SAN FRANCISCO GROUNDWATER SUPPLY PROJECT

Responses to Comments

Planning Department Case No. 2008.1122E
State Clearinghouse No. 2009122075

October 2013

- * City staff has revised EIR page 3-12, Figure 3-8 to revise Sunset Reservoir facilities (see following page).

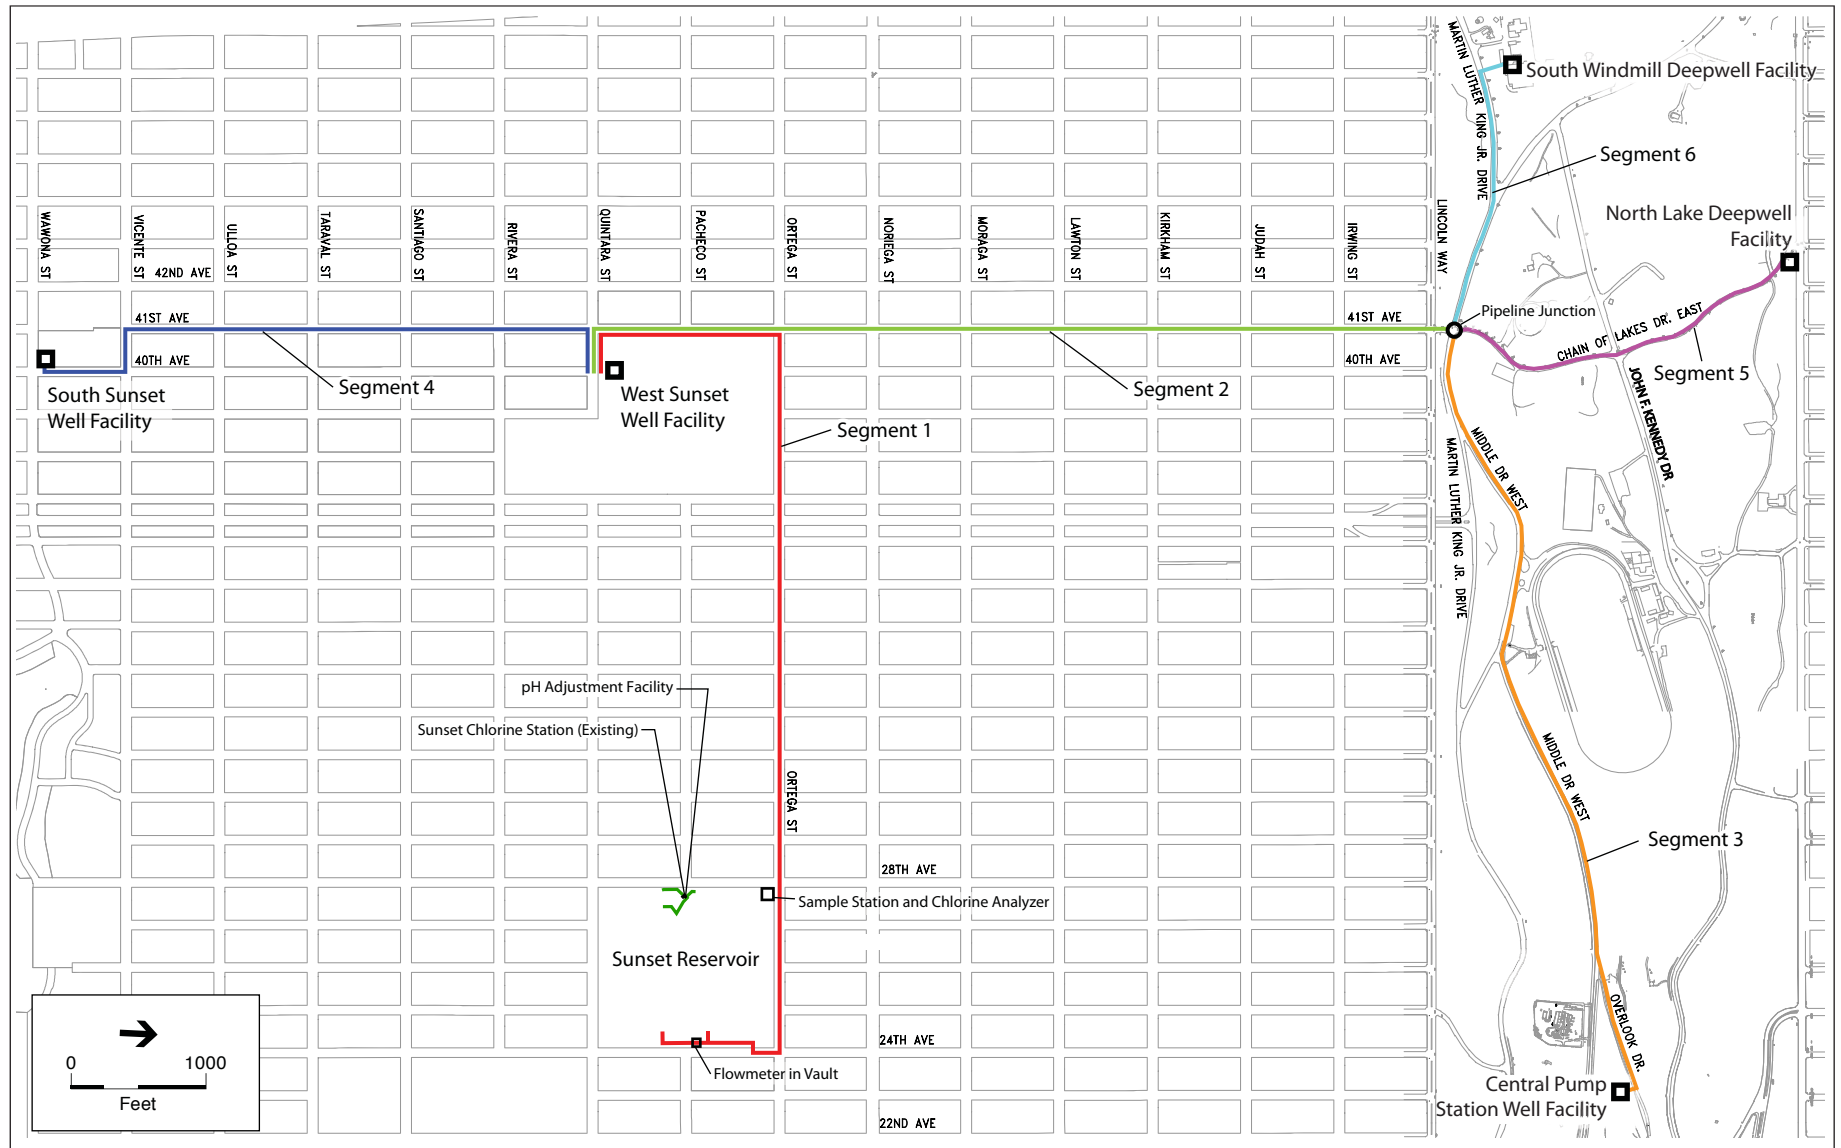
City staff has revised EIR page 3-3, paragraph 1, bullet 3:

- *
 - Construction of a pH adjustment facility at Sunset Reservoir as an addition to ~~within~~ an existing reservoir building and a chlorine analyzer/sample station at the reservoir.

Sunset Reservoir Facilities – Total Construction	<u>48</u> months
---	-------------------------

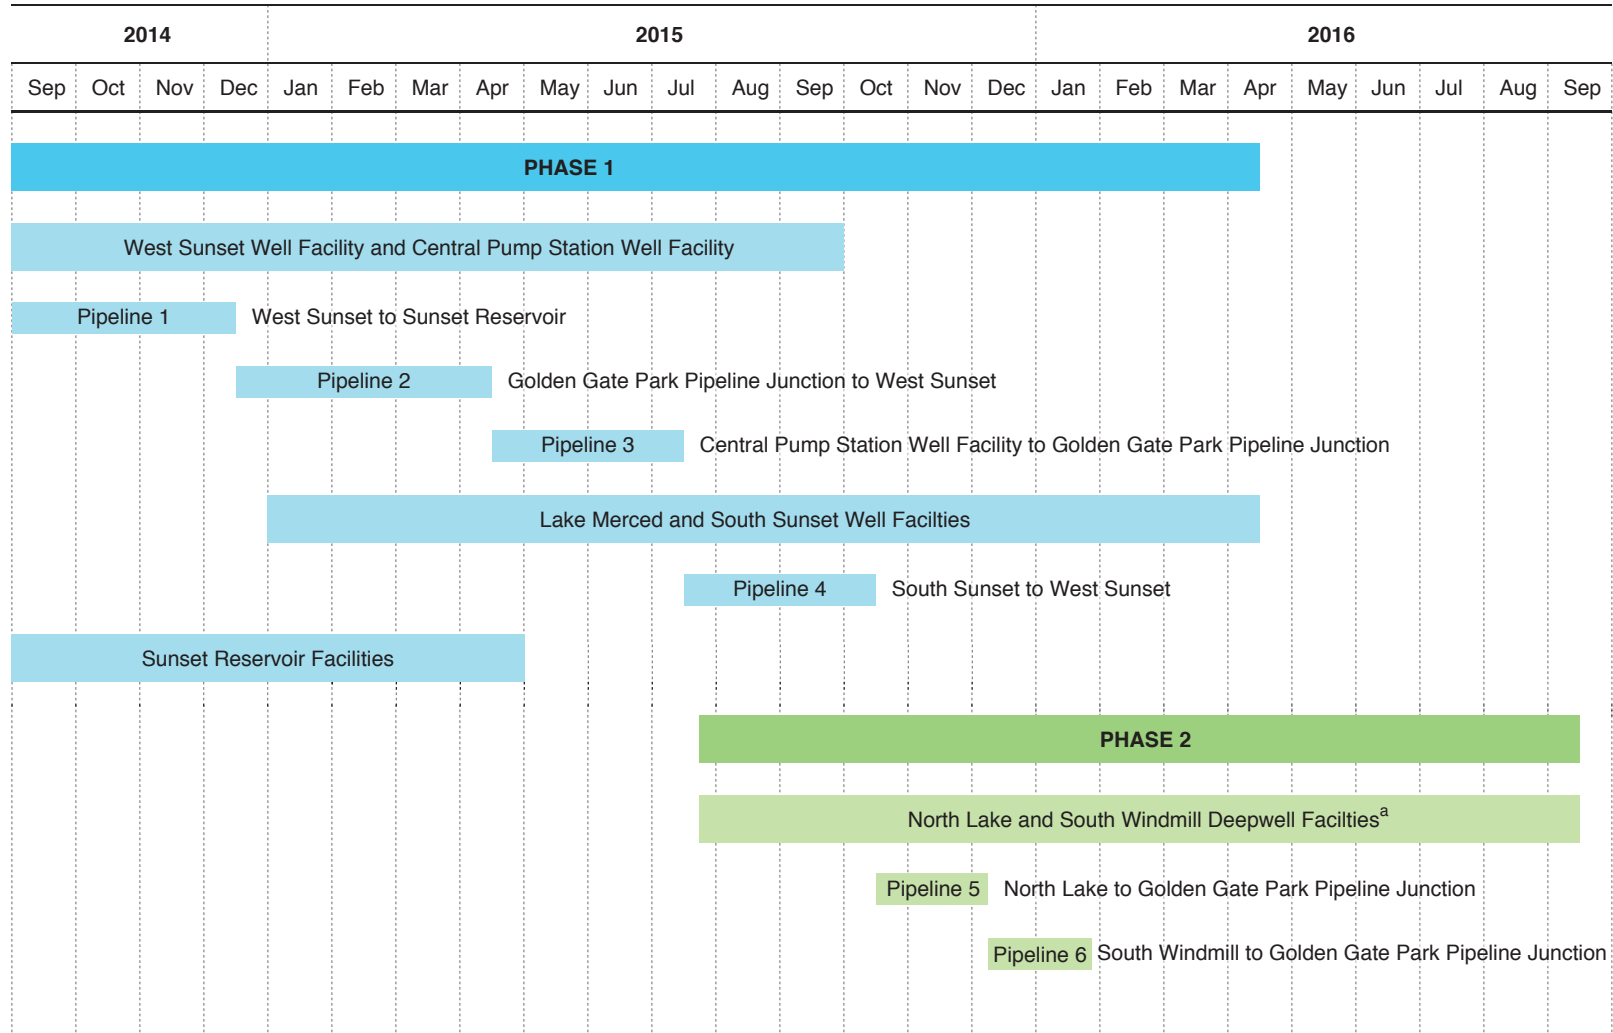
City staff has revised EIR page 3-51, Figure 3-15 to update the construction period for the Sunset Reservoir facilities (see following page).
